SERVICE BULLETIN

APPLICABILITY: 2018-22MY Outback & Legacy

SUBJECT: Security & Locks – Additional Cautions

NUMBER: 07-217-23

ADDITION:

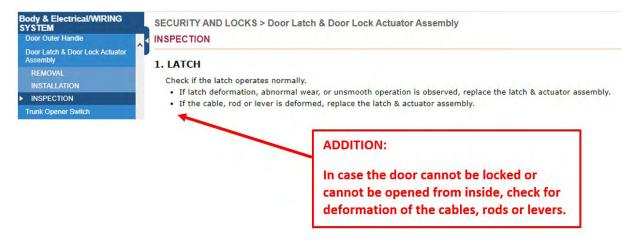
Do not lock the door while the front inside door handle is being pulled. Doing so may damage the locking mechanism and the door cannot be opened from inside or be locked
